N5181A-01

N O T E

N5181A MXG Analog Signal Generator

“Batch related component issue may result in a non-functioning instrument”.

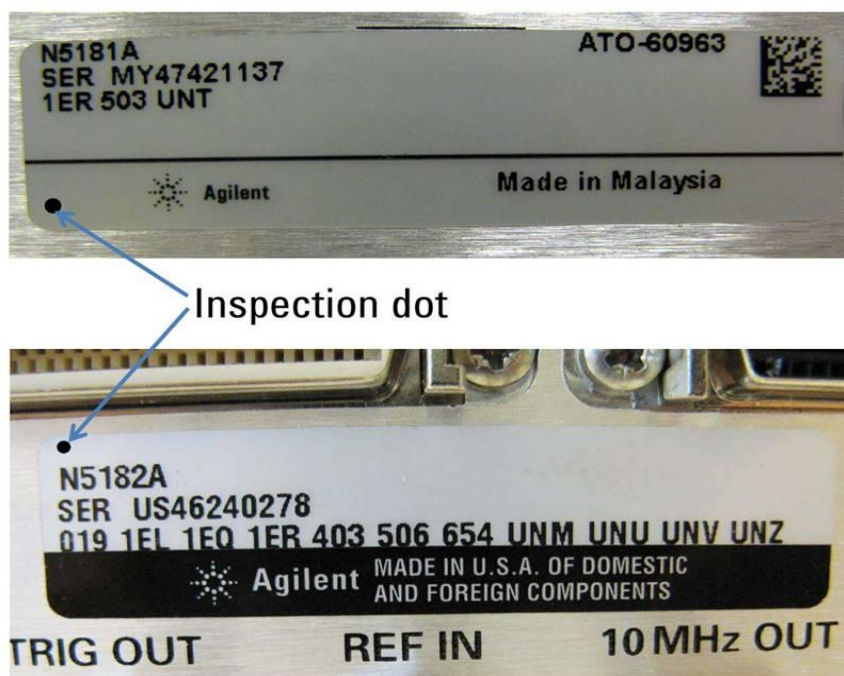
1. Check the rear panel serial tag for a small black inspection dot (see images below). If a black dot is present, similar to what is depicted, the instrument has been checked and no further action is required. If the dot is missing proceed to step 2.
